Enclosure 1
Changes to Hermes 2 PSAR Chapters 3, 5, and 13
(Non-Proprietary)

Figure 5.1-1: Primary Heat Transport System and Intermediate Heat Transport System Process Flow Diagram

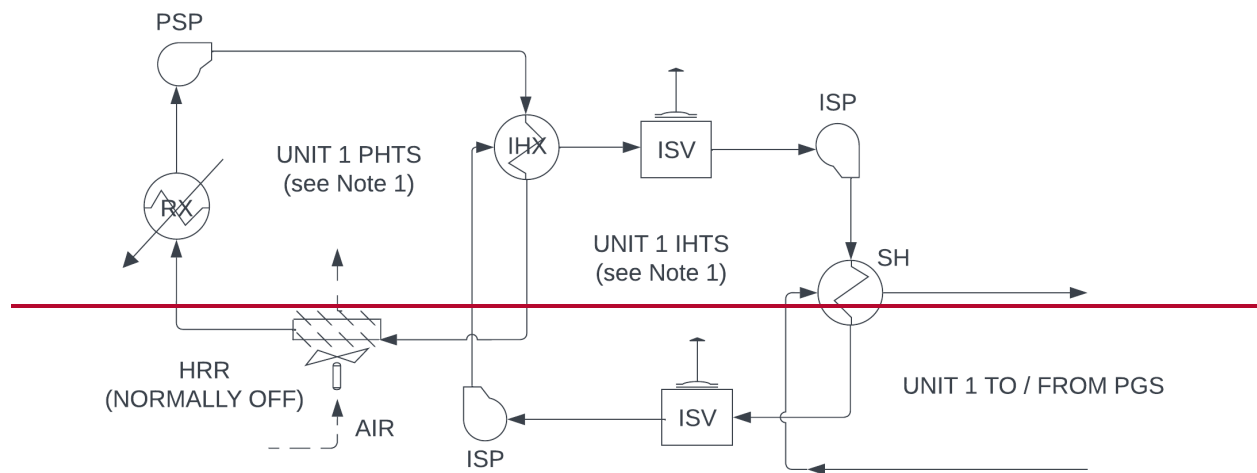
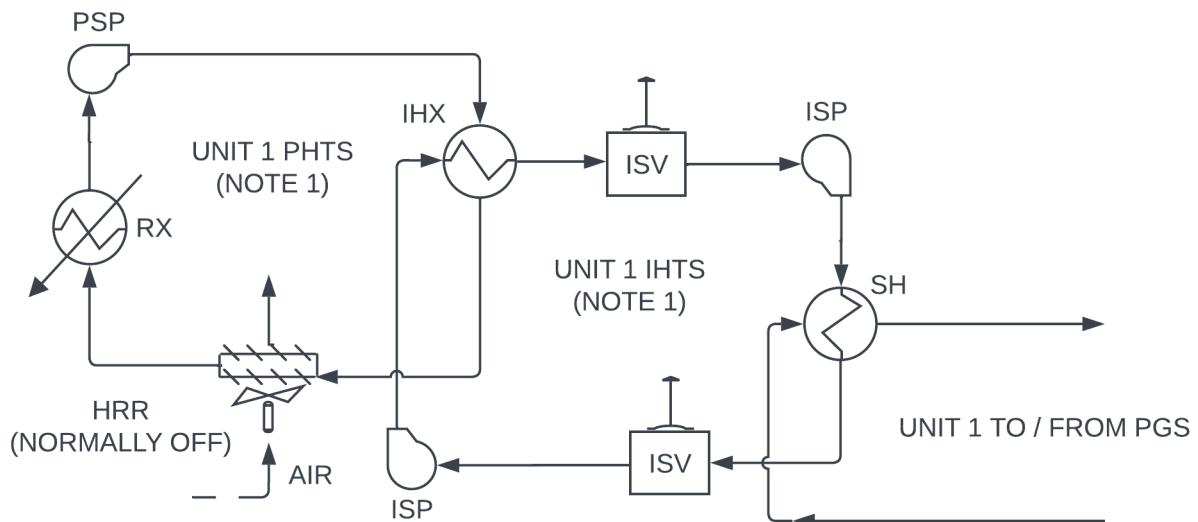
Note 1: Duplicated and separate Unit 2 PHTS and Unit 2 IHTS to/from common PGS

NOTE 1: UNIT 2 PHTS & IHTS ARE SIMILAR
